November 10, 2009

Re: Bicycle Friendly Roundabout for Old/Bear Brook Roads

Figure 4
Bicycle Ramp Access to Shared-use Path ⁽¹⁾

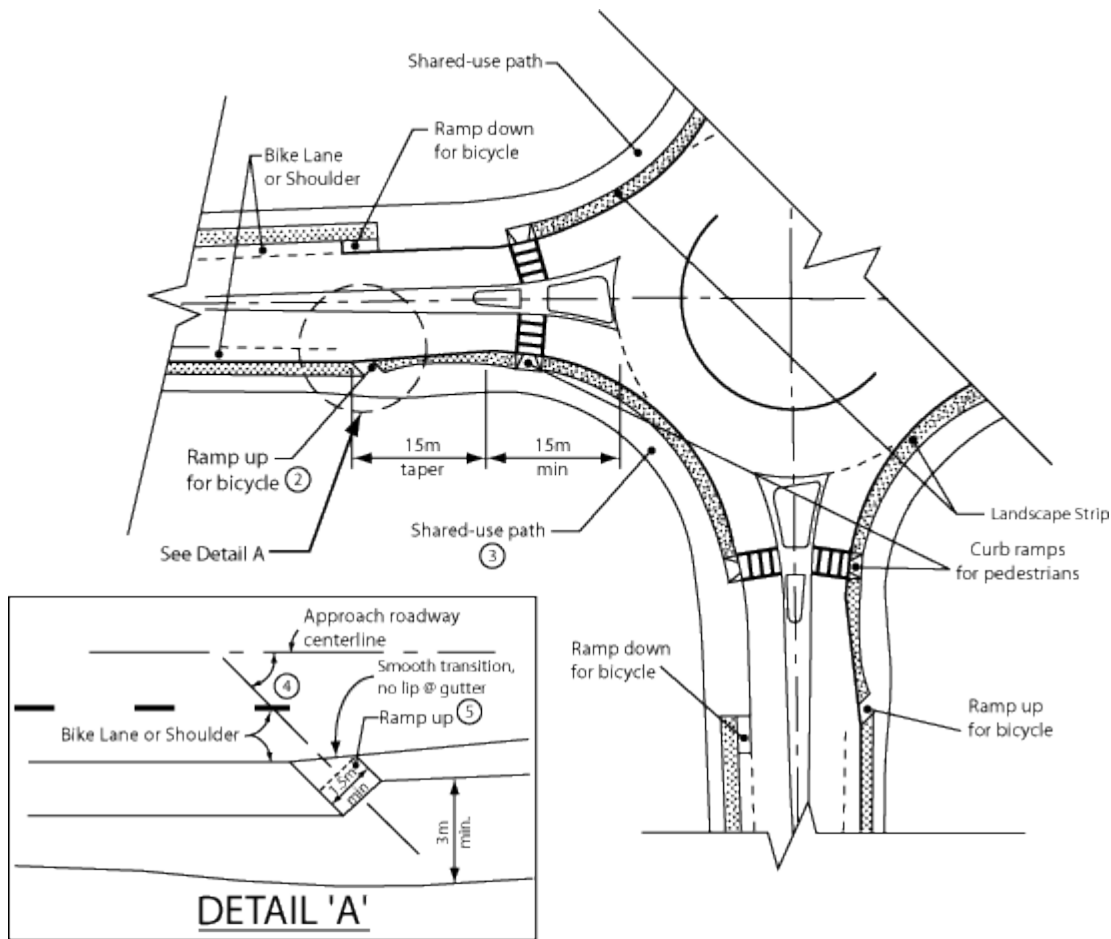
WWBPA strongly recommends improving the design of the Bear Brook roundabout and adjacent area to include

1. on-road bicycle lanes for the entire length of Bear Brook Road,
2. an off-road shared-use path for the entire length of Bear Brook Road,
3. ramps to and from the bicycle lanes and the path at the roundabout,
4. adequate lighting at the roundabout and crosswalks,
5. "Bikes Allowed Use of Full Lane" signs at the bicycle and car lane merge points, per *NJ DOT Bicycle Compatible Roadways and Bikeways Planning and Design Guide*.

<http://www.dot.ca.gov/hq/oppd/dib/dib80-01.htm#fig4> (below).
